CROW BUTTE RESOURCES, INC.
(In Situ Leach Facility, Crawford, NE)Docket No. 40-8943
License SUA-1543

**CONSOLIDATED REQUEST FOR HEARING
AND PETITION FOR LEAVE TO INTERVENE**Office of the Secretary
U.S. Nuclear Regulatory Commission
Washington, DC 20555-0001

Figure 1. Chart of aquifer exempt zone (i.e., zone surrounded by monitoring wells) and locations for baseline wells established with valid statistical methods.

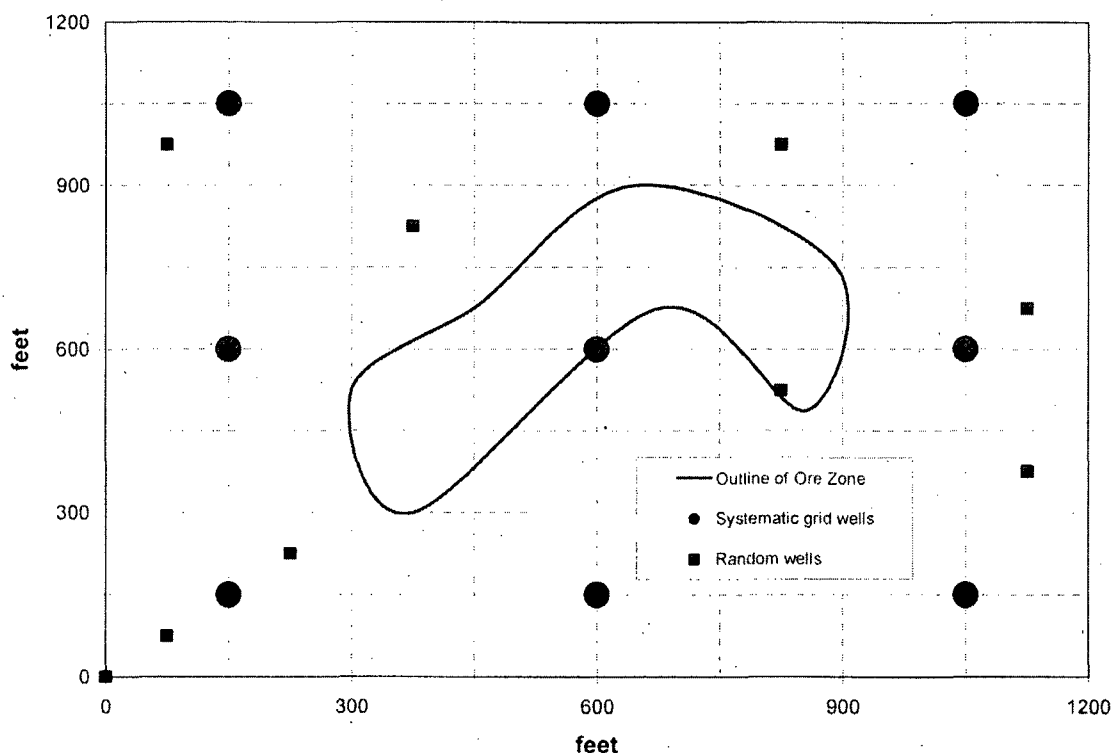
Figure 2.9-2 illustrates the proposed aquifer exemption zone around the ore bodies, and there is no statistical justification for the location of the baseline wells to validate that the results in Table 2.9-4 represent the water quality in the exempt zone. Note that the baseline wells in Figure 2.9-2 are clustered and not spread out over the entire exempt zone, and this violates statistical protocol. Within the aquifer exemption zone (i.e., the zone within the monitoring well ring), a systematic grid must be laid out to determine the location of the baseline water-quality wells. The density of nodes within the grid will be determined by the size of the area and the data quality objectives. Data quality objectives (EPA 2000a & 2000b) state the statistical confidence one wishes to have in the estimate of the mean (normal or log normal distribution) or median (no defined distribution) for the water-quality parameters. If a high level of confidence is required for an estimate of the mean or median, more baseline wells will be required.

For example, if we wish to establish a 95 percent confidence interval on the mean for a normal or log normal set of data, with an estimated standard deviation of 20 and using a half width of 10 for the confidence interval, an exempt aquifer area measuring 1200 by 1200 feet would require a minimum of 9 baseline wells (PNNL, 2007). The location of the wells on the grid nodes is illustrated on Figure 1. The half width of the confidence level is a key consideration in determining the number of wells; as the half width decreases, the number of wells increases. The selected level of confidence and estimated standard deviation also affect the number of wells. A lower level of confidence and lower estimate of the standard deviation would result in fewer baseline wells.

- 9) No justification is provided for the location of water-quality wells within the monitoring ring on Figure 2.9-2. Valid statistical methods must be used to locate the systematic or random samples on a grid than covers the entire area enclosed by the monitoring wells.

Figure 2. Cross section of an aquifer (20 to 90 feet) showing improper (Well 1) and proper (Well 2) sampling intervals to obtain a representative sample.

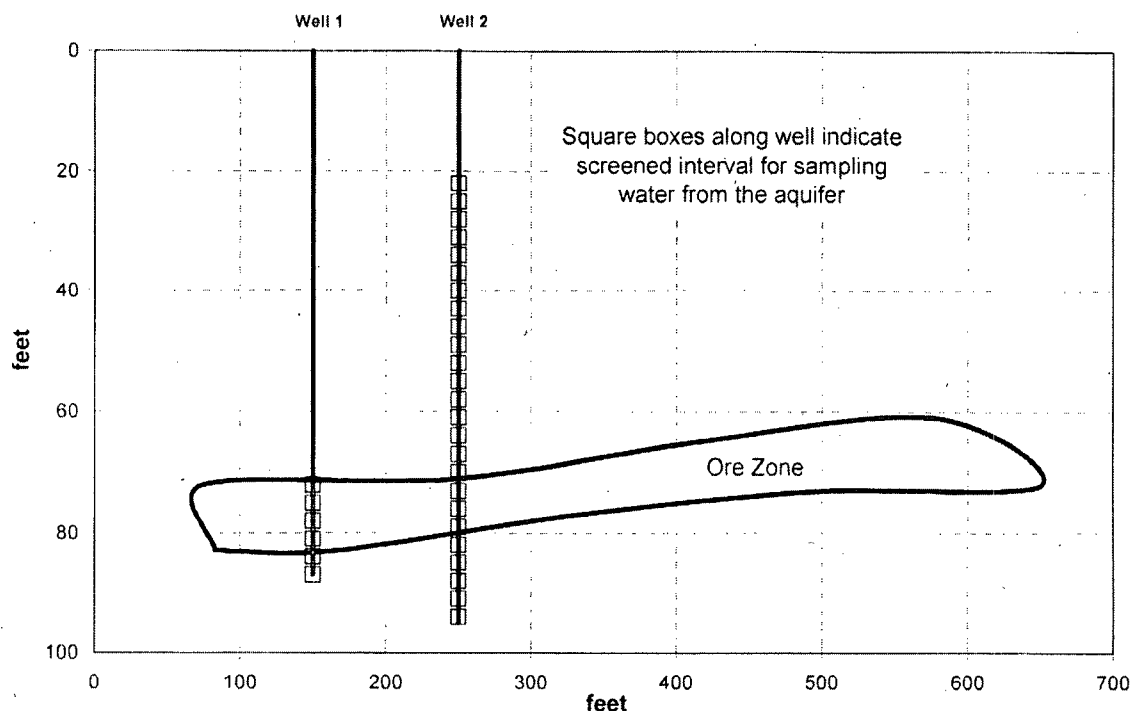
The well logs provided indicate the Chadron is approximately 50 to 80 feet thick through most of the mining area (Figures 2.6-4 through 2.6-11). The sampling interval for the baseline wells is 20 feet (Table 2.9-3), which does not represent the entire thickness of the aquifer. Figure 2 shows that a water sample obtained from Well 1, screened only in the ore zone, returns a biased sample that does not represent the water quality of the column of water at the given location. Well 2 (Figure 2) indicates the correct method for sampling the water, which requires that the entire thickness of the aquifer be screened to obtain a representative sample.

- 6) Figures 2.6-4 through 2.6-11 show the thickness of the Chadron to be 40 to 80-feet thick through most of the mine area. Therefore, it is inappropriate to use a screened interval of 20 feet to sample the groundwater from the ore zone (Table 2.9-3). The entire thickness of the aquifer must be sampled to obtain a representative sample.

Figure 3. Probability plot indicating that all data do not lie near or on a straight line, which rules out a normal or log normal distribution.

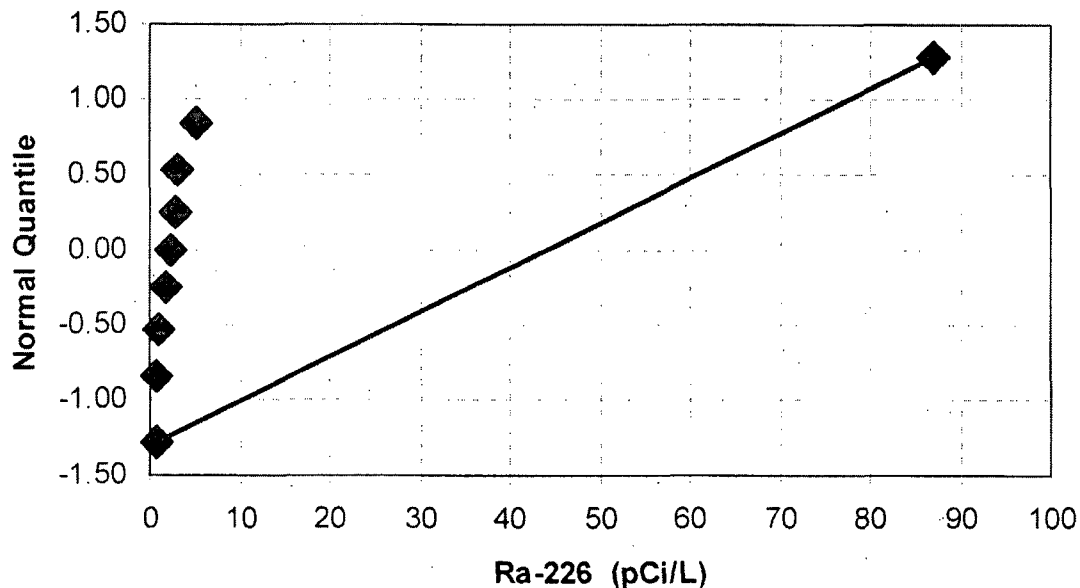
A probability plot of the data (Figure 3) and the results of the Shapiro-Wilk test confirm this. The normal-quantile values must fall on a straight line or the Shapiro-Wilk probability values must exceed 0.05 (at the 95 percent confidence level) for a normal or log normal distribution to be declared, which is clearly not the case. Therefore, the median, and not the mean, must be used to represent the central tendency of the data. Note that inappropriate use of the mean results in a high bias on the estimate of the baseline value for radium-226, which improperly elevates restoration clean-up levels and lowers the costs associated with the number of pore volumes needed to exchange to meet the clean-up levels.

Figure 4. Proper use of a control chart to determine lixiviant excursions.

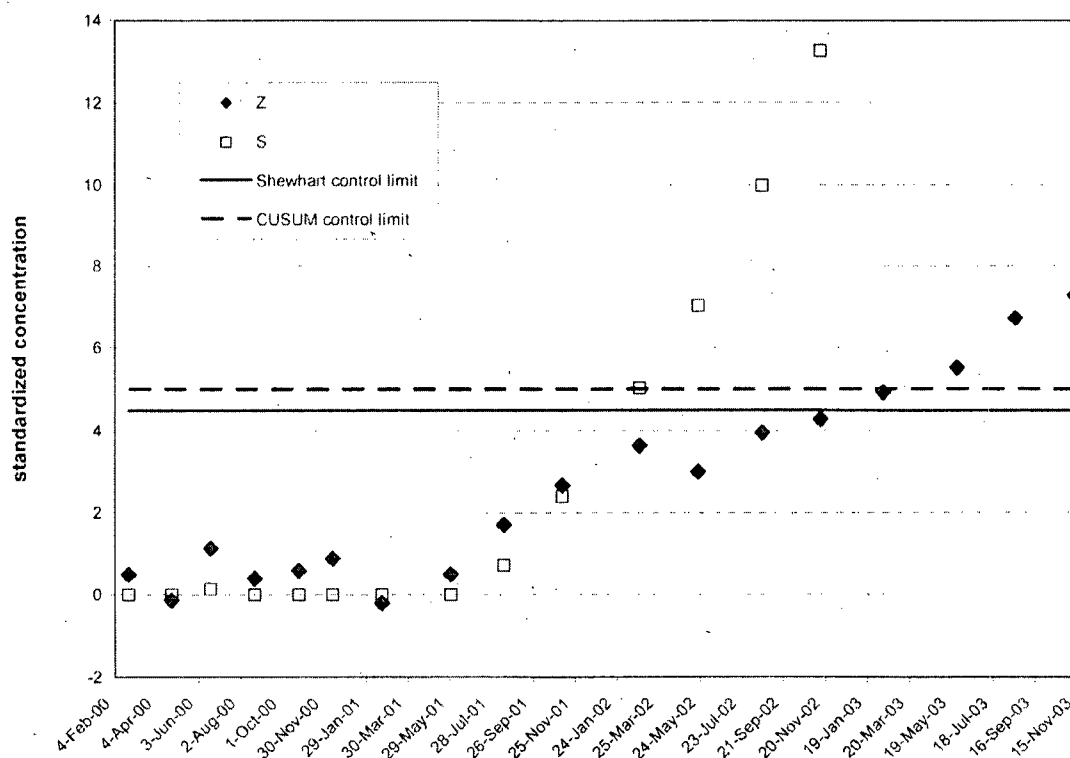
EPA (1992) addresses the use of 4.5 standard deviations added to the mean via the construction of a Shewhart-cumulative sum control chart. The use of this approach is recommended provided that the data follow a normal or log normal distribution. Assuming a sufficient number of samples have been collected at a monitoring well to demonstrate that the measured values follow a normal distribution, two statistical parameters are calculated to evaluate contaminate migration at the well. First, the standardized mean is calculated from the mean and standard deviation (EPA 1992) and compared to the Shewhart control limit (SCL; set at 4.5 standard deviations above the mean) to evaluate a rapid increase in concentration at the monitor well. Second, the cumulative sum (CUSUM; set at 5 standard deviations above the mean) of the standardized means is calculated for each sampling period (EPA 1992) to determine if it has crossed the 'decision internal value' (h). If h is exceeded, it can indicate a rapid or

slow rise in concentration at the monitoring well. A gradual increase is indicated when the CUSUM exceeds h and the standardized mean does not exceed the SCL.

Figure 4 illustrates the importance of using the SCL and CUSUM for monitoring lixiviant excursion. The SCL (Z) and CUSUM (C) are plotted for an excursion parameter, a gradual increase in contamination exceeds the CUSUM limit in February of 2002, while the SCL limit is not exceeded until January of 2003. The SCL limit is similar to the CBR's use of 5 standard deviations above the mean for any one sampling event, although EPA recommends 4.5 standard deviations for any one sampling event. Using only the SCL limit allows contamination to migrate beyond the monitoring well for nearly a year before an excursion is declared. Therefore, if the CUSUM is not used with the SCL limit a gradual increase in contamination will not be detected and migration of diluted lixiviant will pass the monitoring well without corrective action.
